ERRATA SHEET

NUREG/CR-1950

DATA REPORT FOR THE NRC/PNL HALDEN ASSEMBLY IFA-432:  
APRIL 1978 - MAY 1980

FIGURE 16. Local Linear Heat Ratings at Upper Thermocouple Locations for Rods 1, 2, and 3 of IFA-432 from November 28, 1978, to January 26, 1979

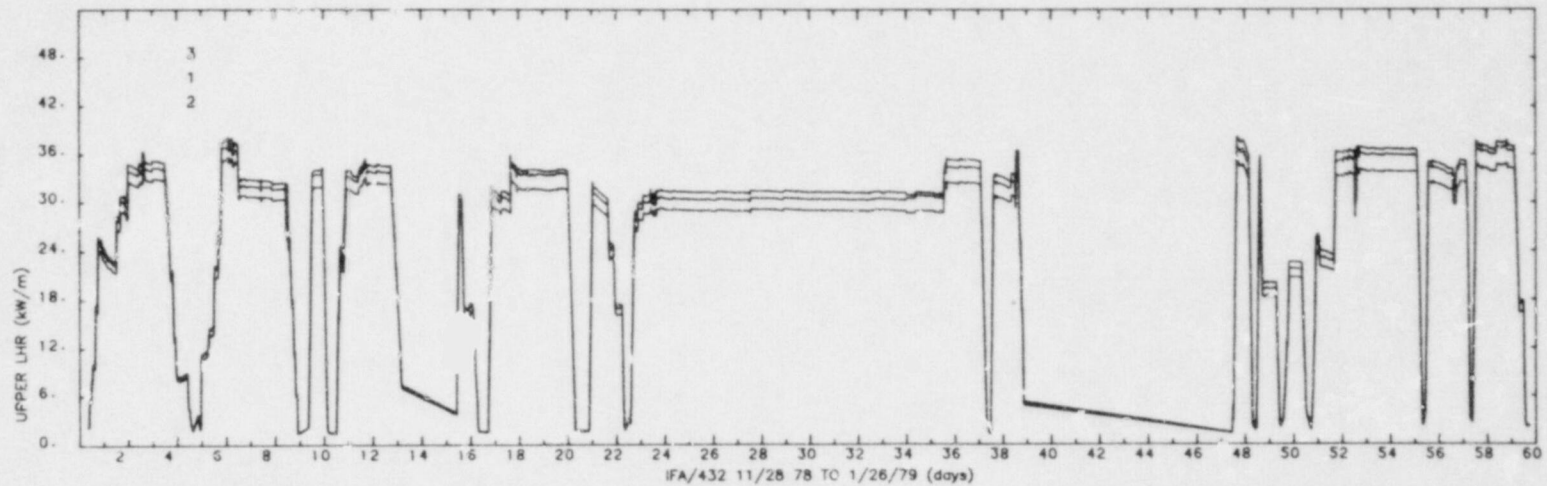
Local linear heat ratings during the period November 28, 1978, to January 26, 1979, were improperly modified for fuel depletion. The originally reported values are low by approximately 15%. Corrected values are shown on attached pages 20 and 21.
